Y1A, Y1B, Y1C- High-Voltage (HV) Battery Measurements during HV Battery Repair

Revision History

Bulletin #: 2518.1

Figure 1 - 28-module HV Battery measurement points

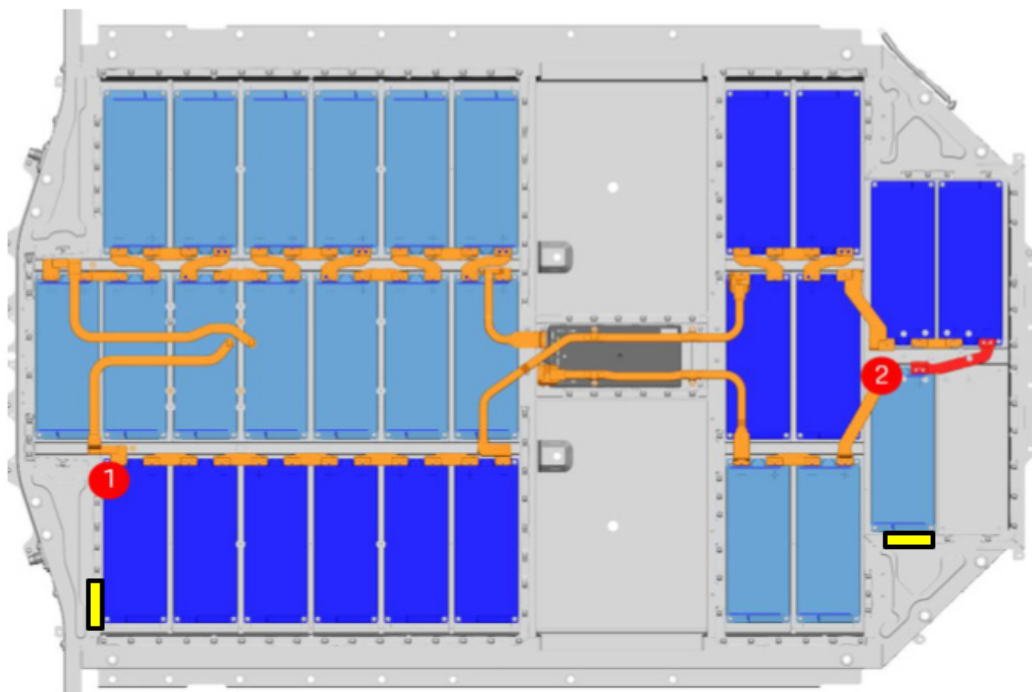
DST Procedure for 28-module Taycan Battery Pack (Figure 1)

- Only two DSTs are to be performed on a 28-module battery pack during repair.
- During a DST, only personnel with a 40 Cal Arc Flash suit and approved PPE may be permitted within the cordoned HV safety zone around the battery pack.

- The busbar indicated in red must be removed prior to measurements at either point.
- Perform an IR test at points 1 and 2 before the DST at those points.

- Perform a DST only at points 1 and 2 shown below for each repair scope.
- The yellow boxes in *Figure 1* designate the sections of laser clean surface (silver stripe) to contact using the negative probe to ground the dielectric strength tester. This method ensures consistency in testing.

- Also perform IR tests at points 1 and 2 after a DST, with the negative probe also on the surface designated by the yellow boxes.
- If the DST at measurement point 1 fails, remove busbars and CMC connections from each module shaded in dark blue for further IR testing as described in the following *Updated IR Measurement Procedure* sections.

- If the DST at measurement point 2 fails, remove busbars and CMC connections from each module shaded in light blue module for further IR testing as described in the following *Updated IR Measurement Procedure* sections.

- EXAMPLE: Point 1 passes DST and point 2 fails.
 - Perform IR tests on each light blue module in the failing section (In this example, section 2). No additional work is required for the passing modules in section 1.

Figure 2 - 33-module HV Battery measurement points

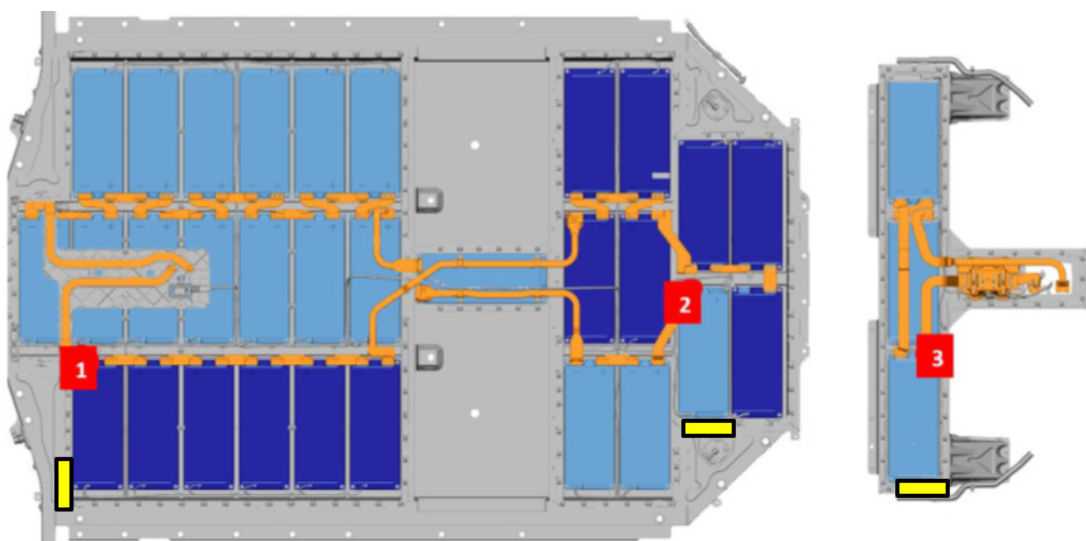
DST Procedure for 33-module Taycan Battery Pack (Figure 2)

- Only a total of three or four dielectric strength tests are to be performed on the 33-module battery pack during repair, depending on scope.
- If removed, the upper "T" Section should be placed aside on a VAS 6762/44 Insulating mat during testing.

- Perform an IR test at points 1, 2 and 3 before the DST at those points.
- Perform a DST only at points 1, 2, and 3 for any repair scope involving the lower-level modules.

- Repair scopes in only the upper "T" section require an initial DST (in addition to the points in *figure 2*) at the mid-pack fuse as shown in step 3.9.3 of Safety test after assembly work on the high-voltage battery with 33 modules in WM 270803A5. If the DST fails, proceed with removing the lower lid and perform DSTs at points 1, 2, and 3 as identified below.

- The yellow boxes in *Figure 2* designate the section of laser clean surface (silver stripe) to contact using the negative probe to ground the dielectric strength tester. This method ensures consistency in testing.

- Perform IR tests at points 1, 2, and 3 after a DST, with the negative probe also on the surface designated by the yellow boxes.
- If the DST at measurement point 1 fails, remove busbars and CMC connections from each module shaded in dark blue for further IR testing as described in the following *Updated IR Measurement Procedure* sections.

- If the DST at measurement point 2 fails, remove busbars and CMC connections from each module shaded in light blue for further IR testing as described in the following *Updated IR Measurement Procedure* sections.

- If the DST at measurement point 3 fails, remove busbars and CMC connections from each module in the upper "T" section for further IR testing as described in the following *Updated IR Measurement Procedure* sections.

- EXAMPLE: It is possible for battery to have point 1 pass, point 2 pass, and point 3 fail the DST. It would then only be required to perform further IR tests on each module in the upper "T" section. No additional work would be required for the passing lower sections.

Figure 3 - IR Test at Positive Terminal

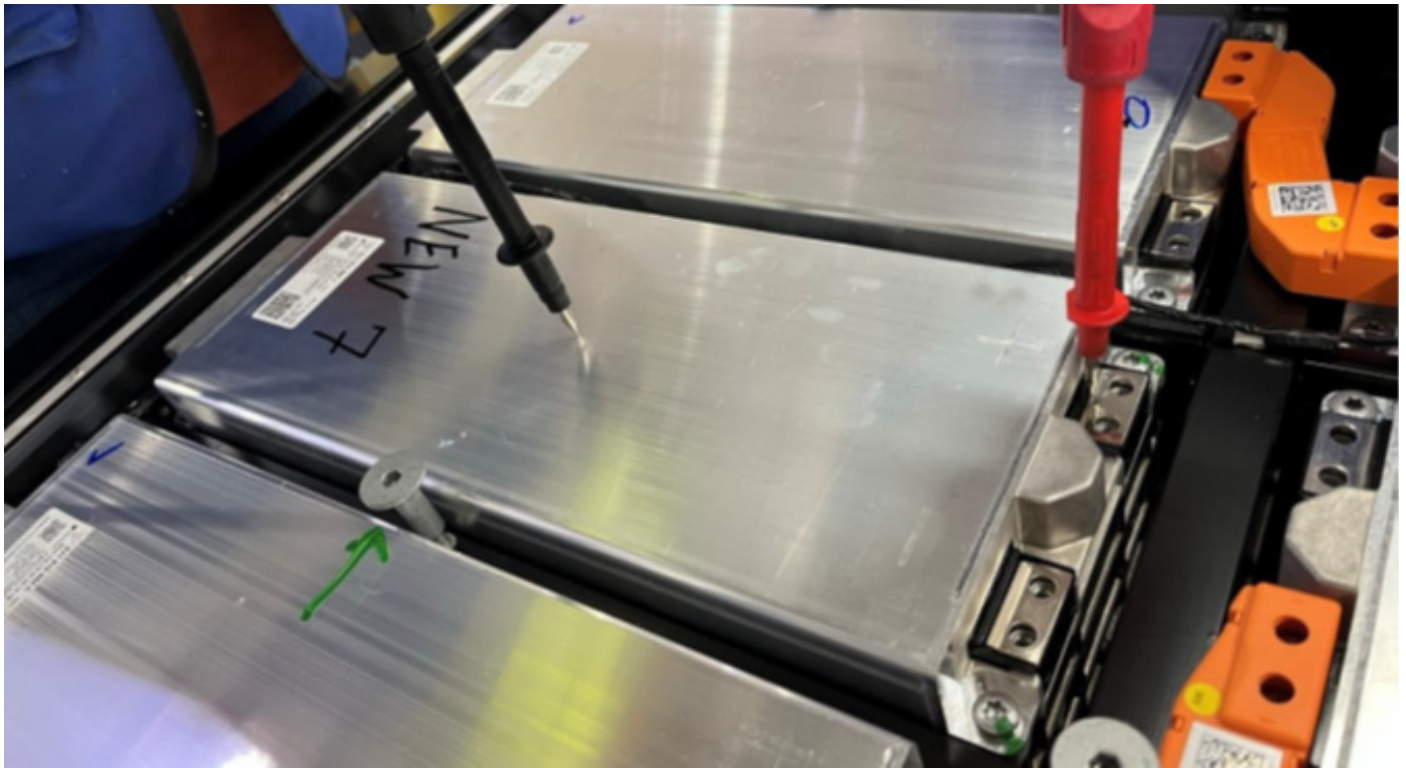
Module IR Testing Procedure: Positive Terminal (Figure 3)

- Place the red probe at the edge closest to the black plastic surrounding the terminal to avoid scratching the conductive surface.
 - CAUTION: pay attention to the angle of the red probe in this case. Avoid contact with the side of the probe and the edge of the module housing. Use a plastic probe cap to expose only the tip of the probe if available.
- Maintain contact with the black probe to the module case in the center. Ensure that the module casing surface is clean at the point of contact.
- The equipotential bonding cable is not suitable as a ground point during this test. Use both straight probes directly on the module to isolate conductive influences.

Figure 4 - IR Test at Negative Terminal

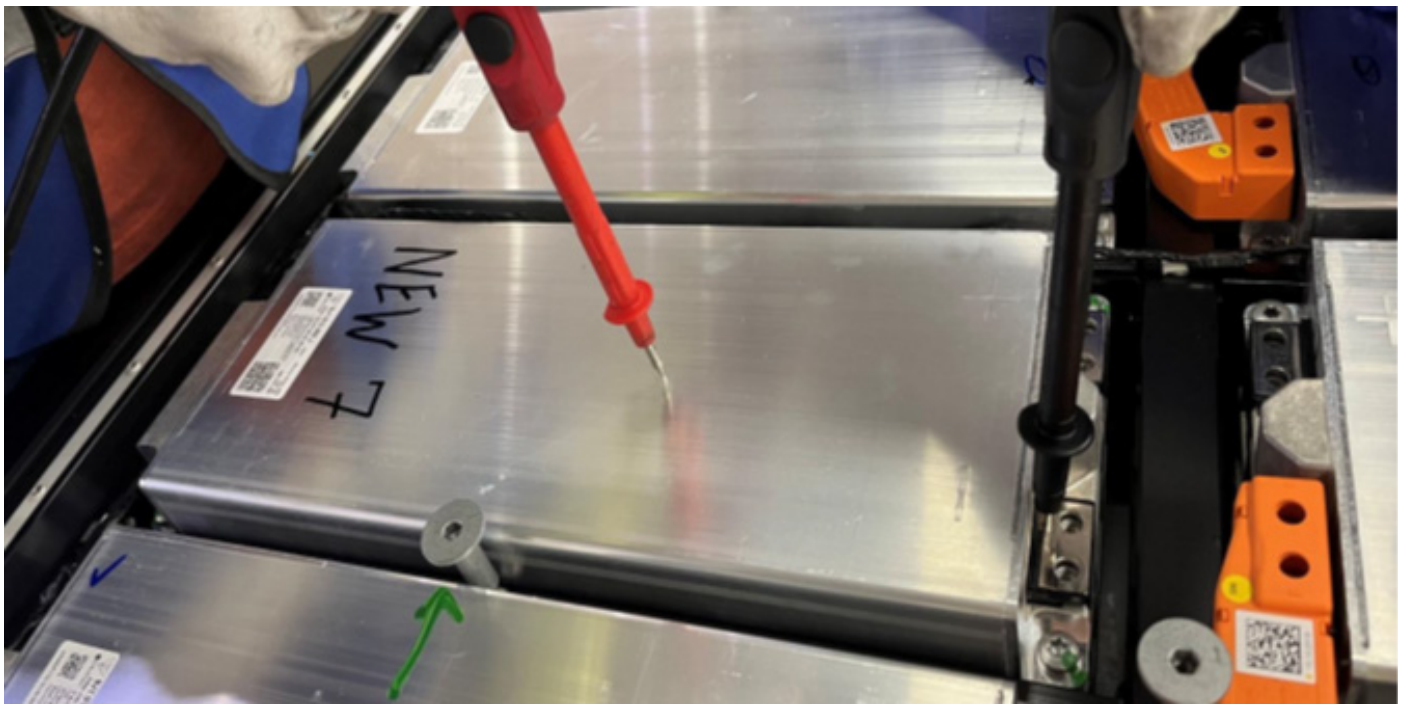
Module IR Testing Procedure: Negative Terminal (Figure 4)

- Place the black probe at the edge closest to the black plastic on the terminal to avoid scratching the conductive surface.
 - CAUTION: Pay attention to the angle of the black probe in this case. Avoid contact with the side of the probe and the edge of the module housing. Use a plastic probe cap to expose only the tip of the probe if available.
- Maintain contact with the red probe to the module case in the center. Ensure that the module casing surface is clean at the point of contact.
- The equipotential bonding cable is not recommended as a ground point during this test. Use both straight probes directly on the module to isolate conductive influences.

Figure 5 - Insulation resistance measurement in PIWIS Tester

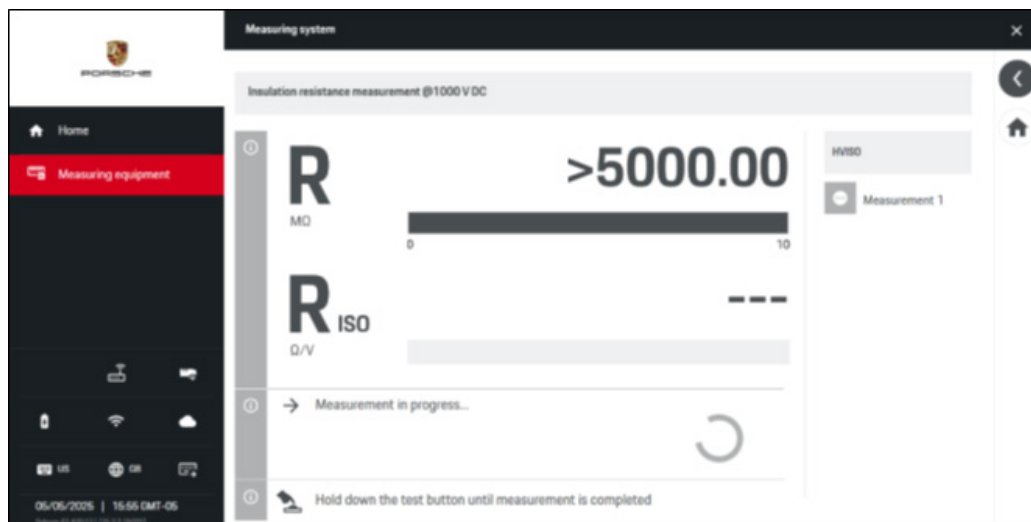
IR Testing Pass/Fail Criteria (Figure 5)

- Shown below is an example of passing test result of >5000 MΩ. This is the reading when IR measures above the 500 MOhm measuring threshold.
- If the first IR test on either module terminal fails, but the second one passes, the module is okay and should not be replaced.
- If any second terminal IR test shows a number below 500 MΩ, this is considered a failure.
- Document any failures in the "Module insulation Resistance Template" Excel file attachment and attach to the PRMS Ticket and repair PCSS entry.
